Technical Service Bulletin: TSB170079	Released Date: 31-Aug-2017
Incorrect Aftertreatment Part Number Etching

Incorrect part numbers etched on aftertreatment components.

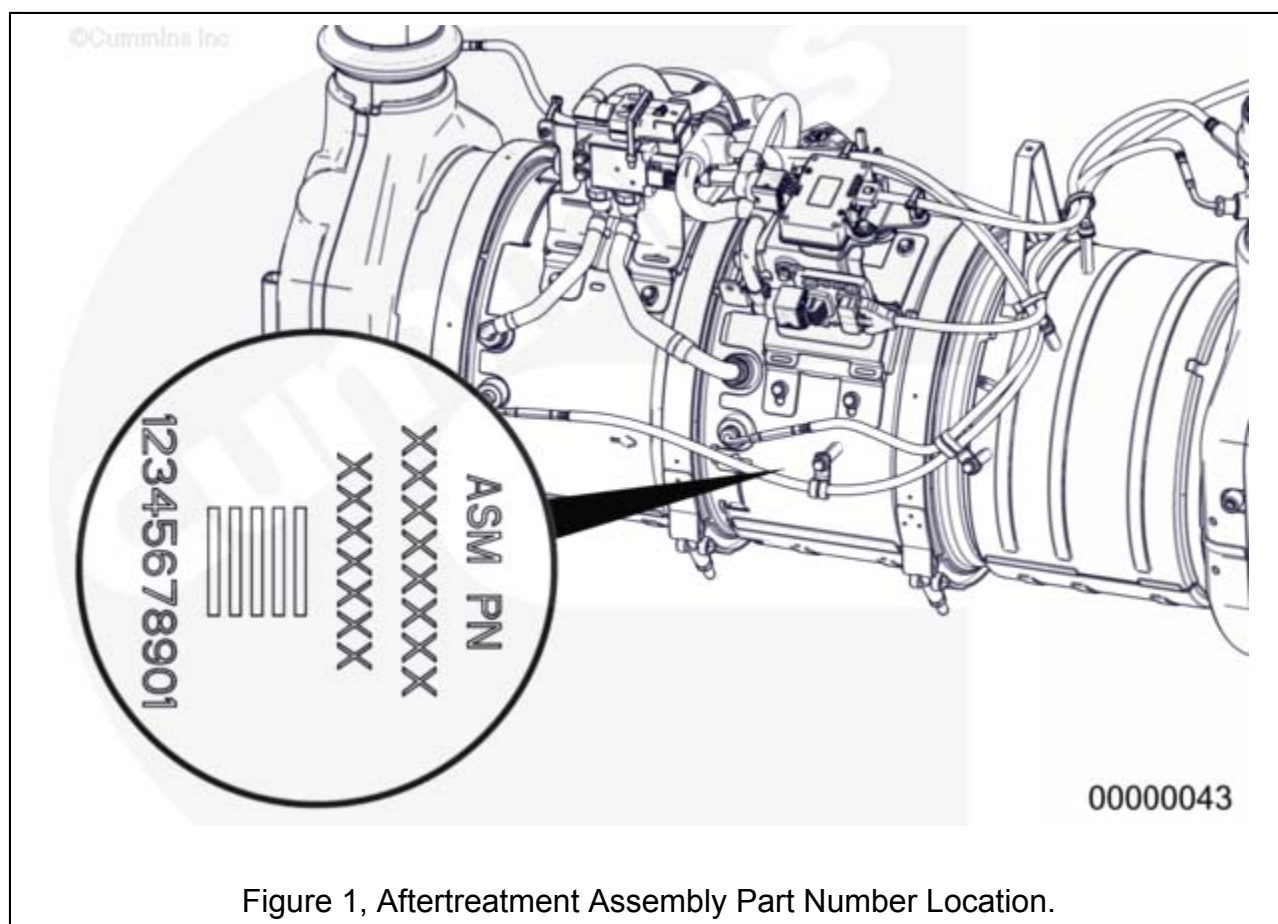
- Figure 1 below displays location of entire assembly part number, which can guide in further identification of needed individual parts.
- Figure 2 below displays location of E PN and C PN on aftertreatment DOC.
- More information about part number identification and location can be found in the corresponding service manual.
 - See B6.7 CM2350 B121B Service Manual, Bulletin 5411223. Refer to Procedure 100-001 (/qs3/pubsys2/xml/en/procedures/455/455-100-001.html) in Section E.
 - See L9 CM2350 L116B Service Manual, Bulletin 5411330. Refer to Procedure 100-001 (/qs3/pubsys2/xml/en/procedures/459/459-100-001.html) in Section E.
 - See X15 CM2350 X114B Service Manual, Bulletin 5411181. Refer to Procedure 100-001 (/qs3/pubsys2/xml/en/procedures/377/377-100-001.html) in Section E.
